Memorandum

TO	Paul Barrett	FROM	Neil Thomas, Laura Drummond, Hilary Lough
	Hawke's Bay Regional Council	DATE	5 May 2022
RE	Review of further information for applications to take and use Ruataniwha Tranche 2 groundwater

PROJECT
Ruataniwha Tranche 2 Review

FIGURE 1:
Low flow rates and modelled impacts upstream and downstream of augmentation discharges

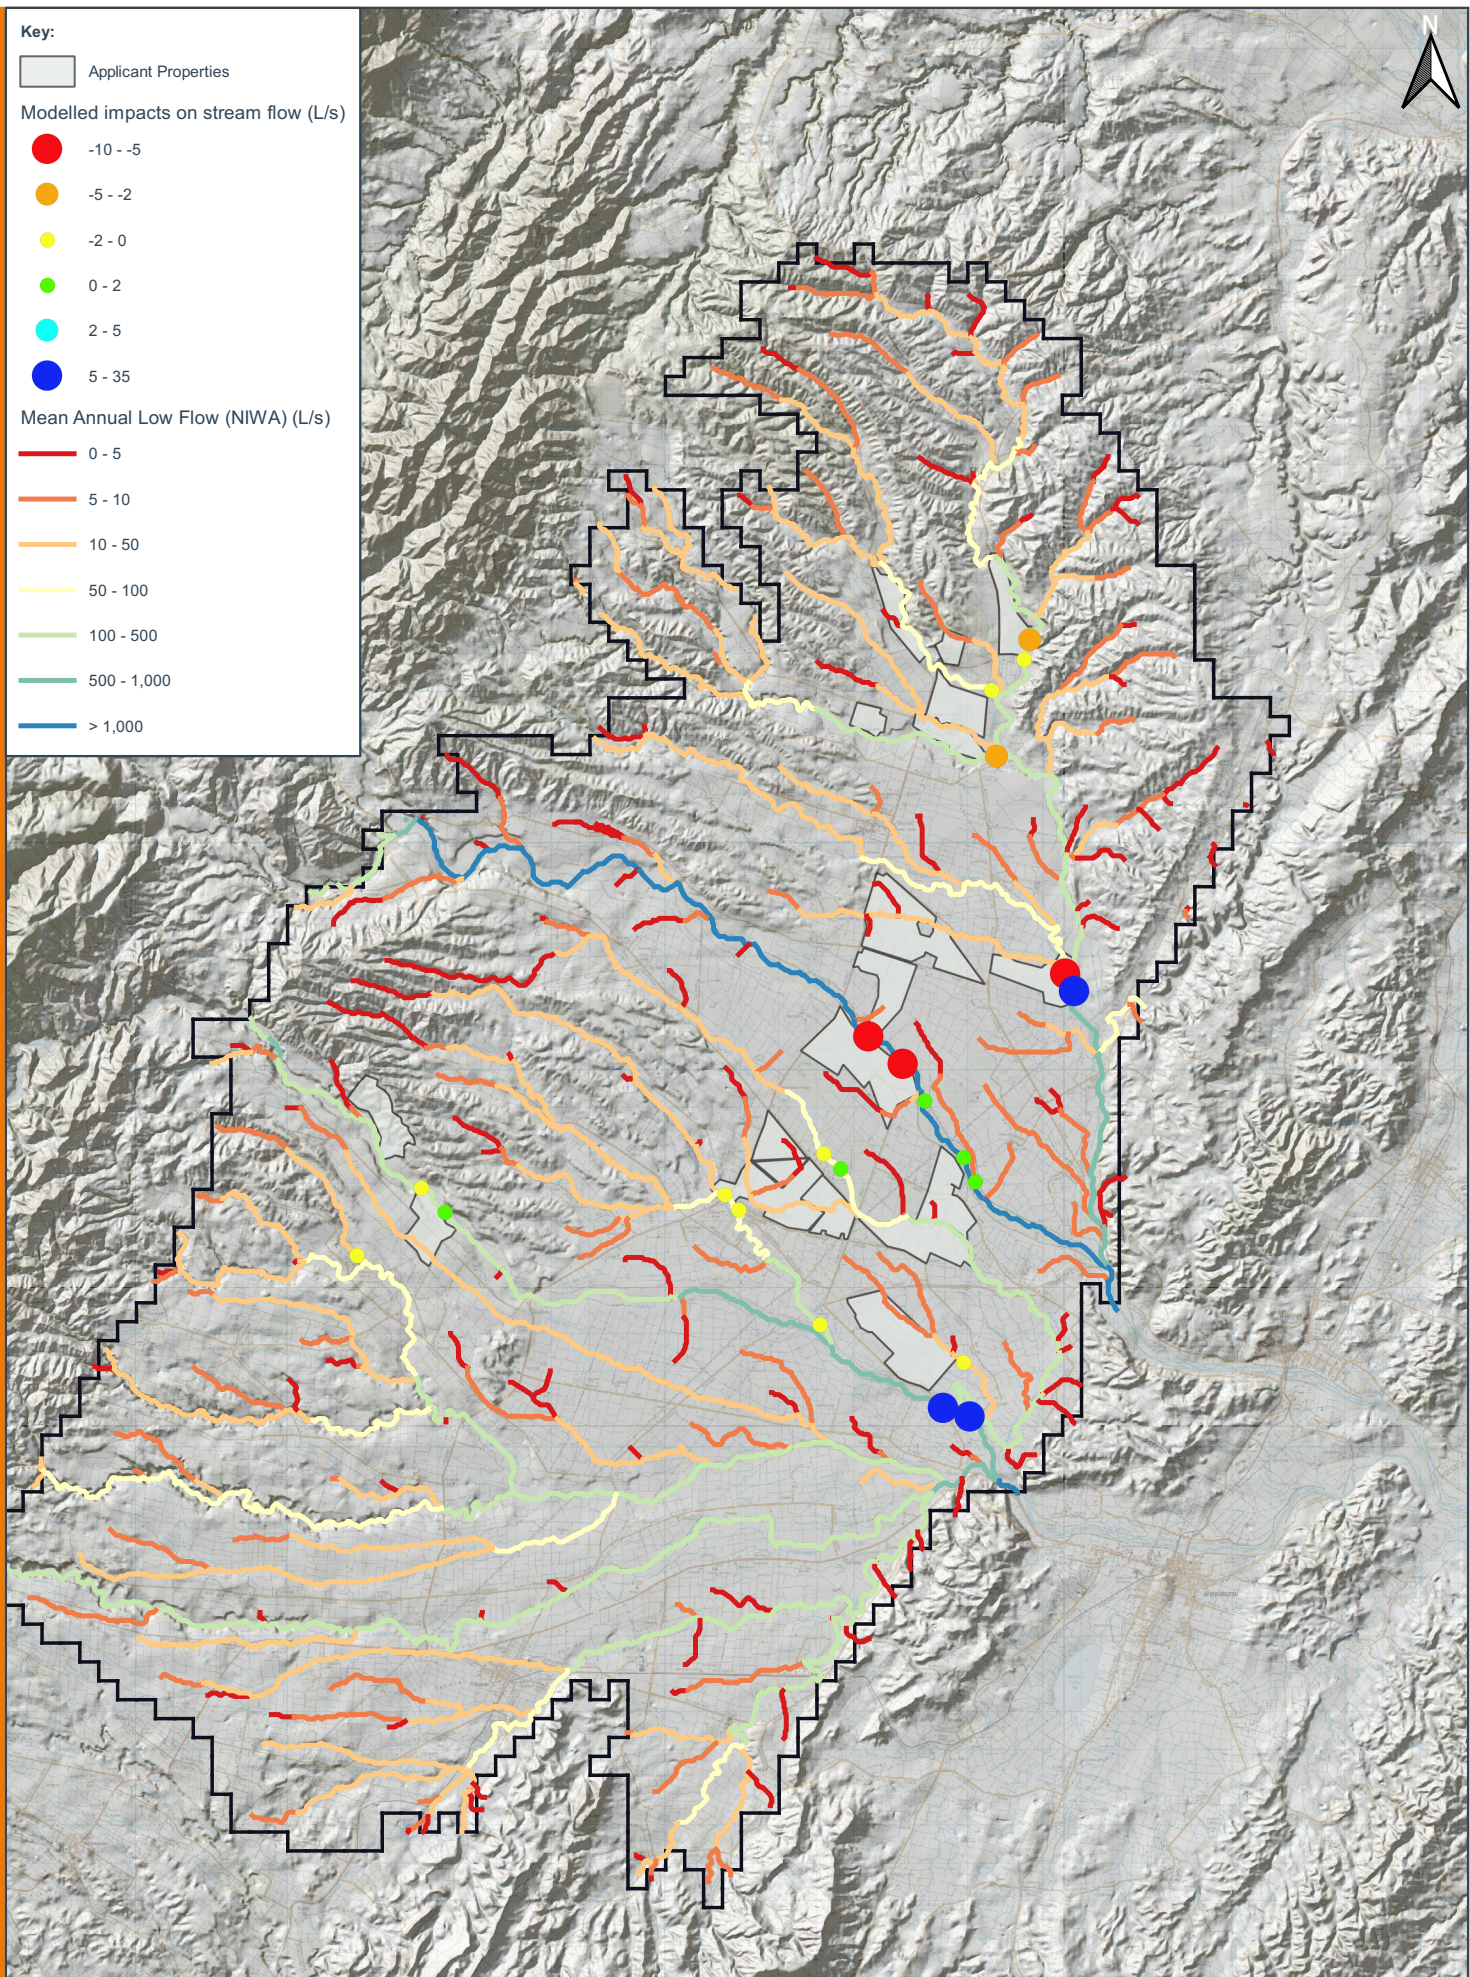
However, in the context of the streams that are affected, these effects could represent a significant proportion of the flow. For example, Aqualinc have estimated stream depletion effects on the Mangaoho Stream upstream of the augmentation due to pumping from the Springhill Dairies abstraction as up to 7 L/s, yet based on NIWA flow modelling, the 1 in 5 year low flow in this reach of the Mangaoho Stream is around 50 L/s. We note that the effect from Springhill Dairies would be in addition to any existing effects.

Therefore, in our opinion, there is uncertainty in the assessments provided by Aqualinc and effects on smaller streams and rivers are potentially significant relative to the flows in those streams. The additional information provided does not allay this concern, although further information to demonstrate that the model suitably represents the local strata at all locations and local groundwater and surface water interaction would be helpful to increase confidence in the model.

FIGURE 2:
 Locations of mapped wetlands (not to scale)

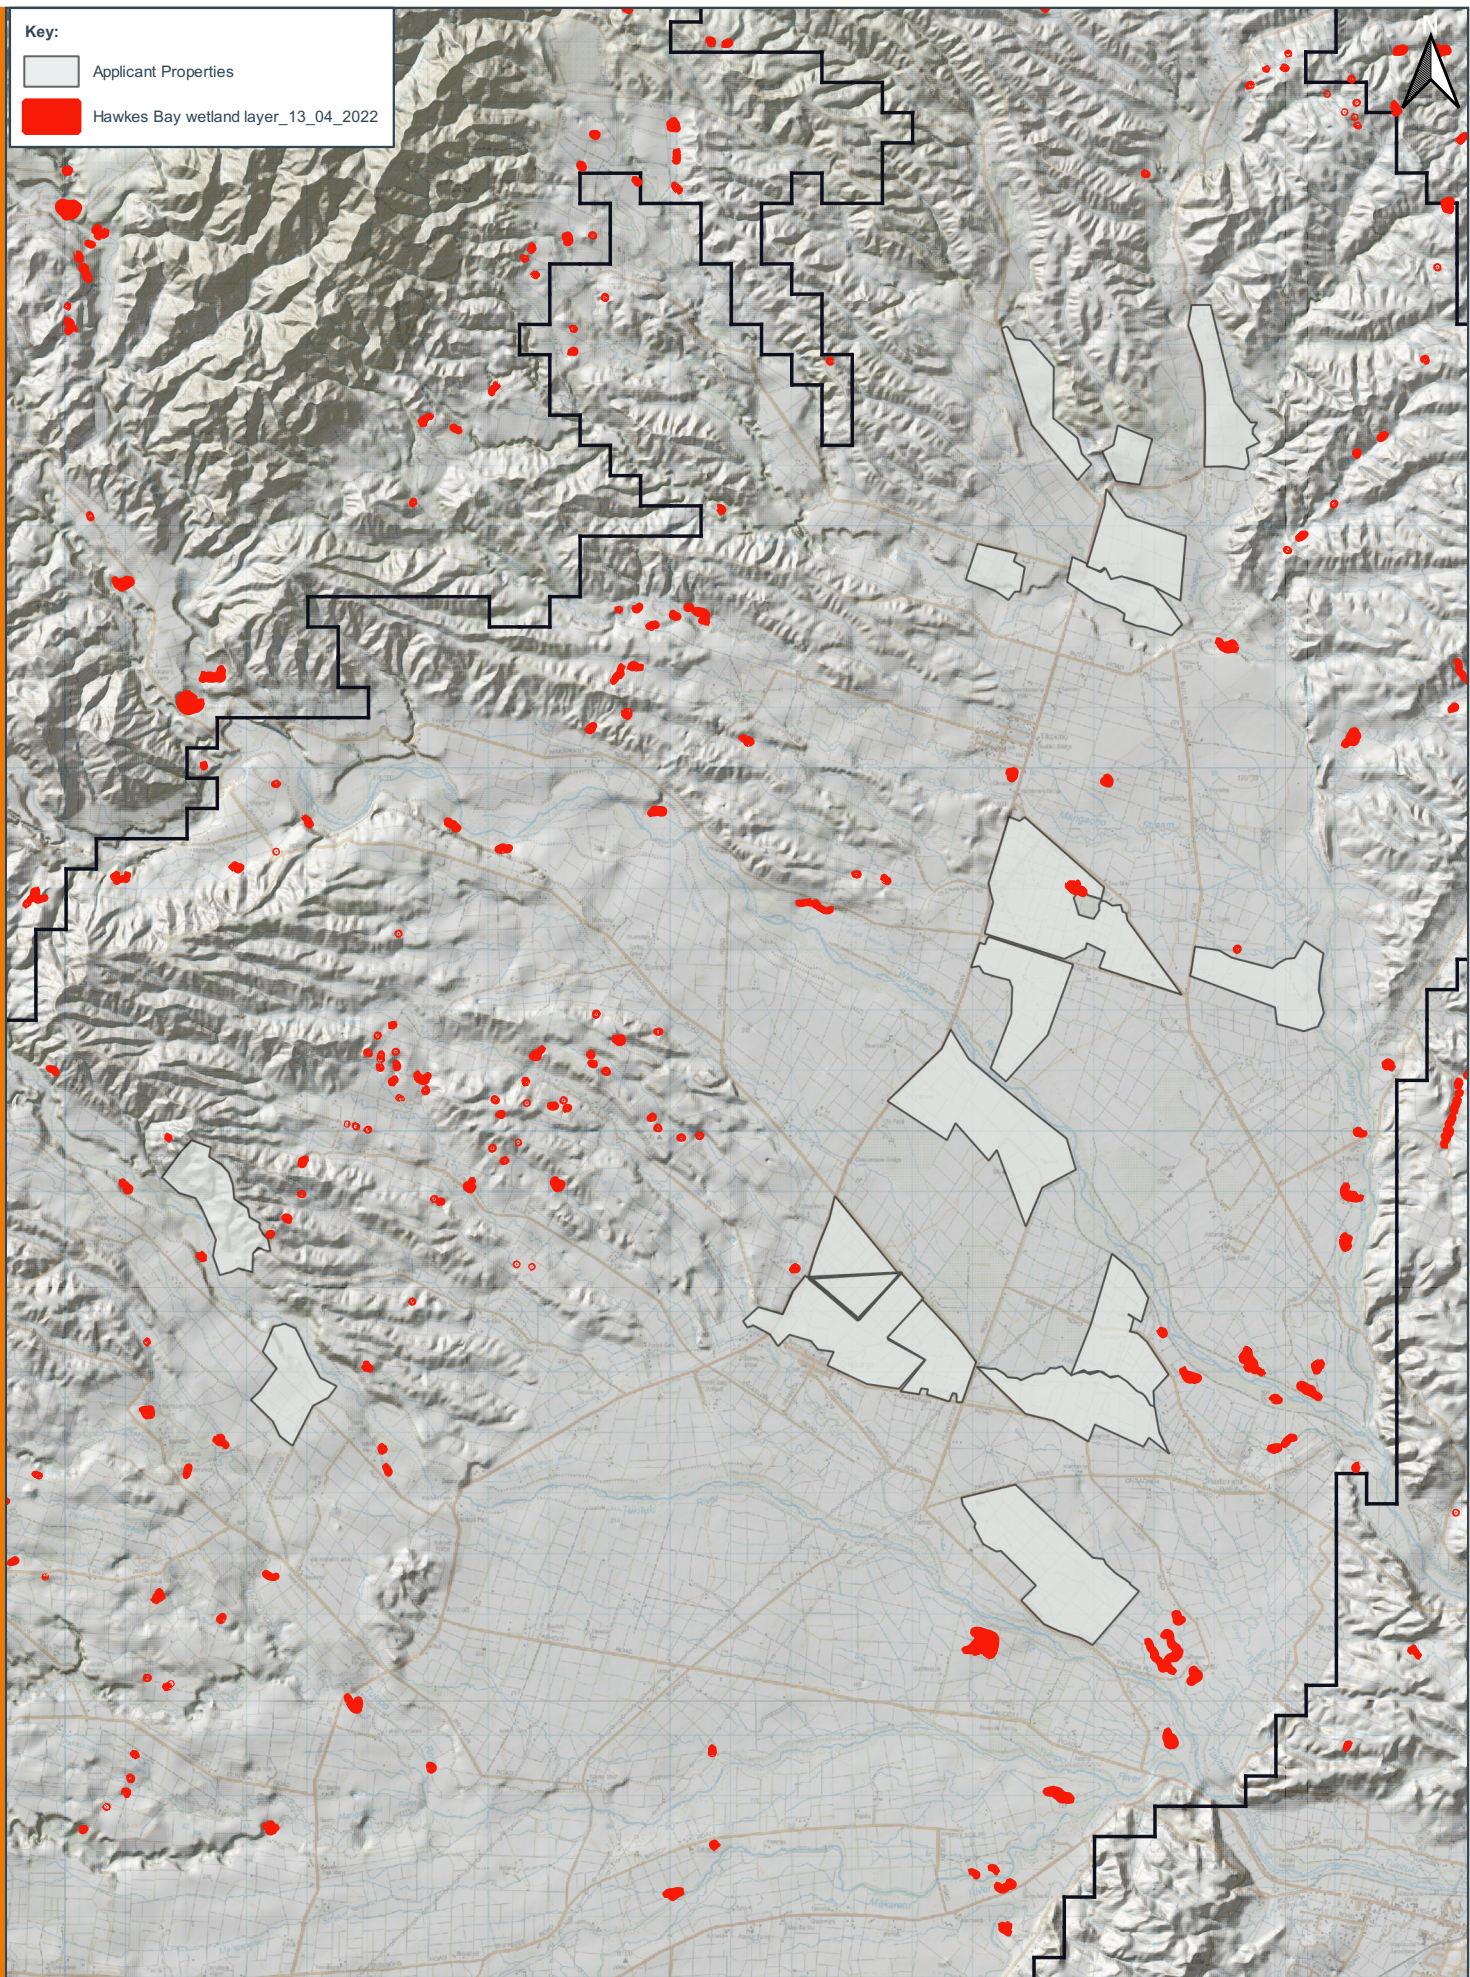
Boffa Miskell conducted a desktop review and high-level walkovers to determine potential effects to wetlands within the Tranche 2 area (Keesing, 2021). The assessment has not used the HBRC wetland inventory (which was not available at the time of assessment) and only one wetland has been classified in the ecological report as a 'natural inland wetland' under the NPS-FM. There is no mention on the Inglis Bush Reserve and associated wetland, or riparian wetlands associated with potentially affected streams and rivers. The HBRC wetland inventory has been peer reviewed, but not ground truthed therefore it cannot be taken as a definitive list of wetland presence; however, a draft version has been made available, and we have provided in Figure 2 a high-level overview of the mapped wetlands in relation to the consent properties. There are a number of mapped possible wetlands adjacent to and downgradient of the consent properties that have the potential to be impacted. We note that many of the wetlands assessed in Keesing (2021) were considered as artificial/constructed and were not classified as not being 'natural inland wetlands' based on formal delineation following the MfE protocols, but based on the presence of some artificial components being present. Often, those 'man-made' systems will be modified natural wetlands, for example a landowner could have blocked drainage to create more open water, and wetland habitat (including flora and fauna) adapt to this new area. Therefore, consideration for their 'current' values should be included in the assessment.

Based on the assessments provided, we do not agree that there will be 'less than minor' effects on wetlands, as the assessment completed is too broad to robustly determine potential effects.
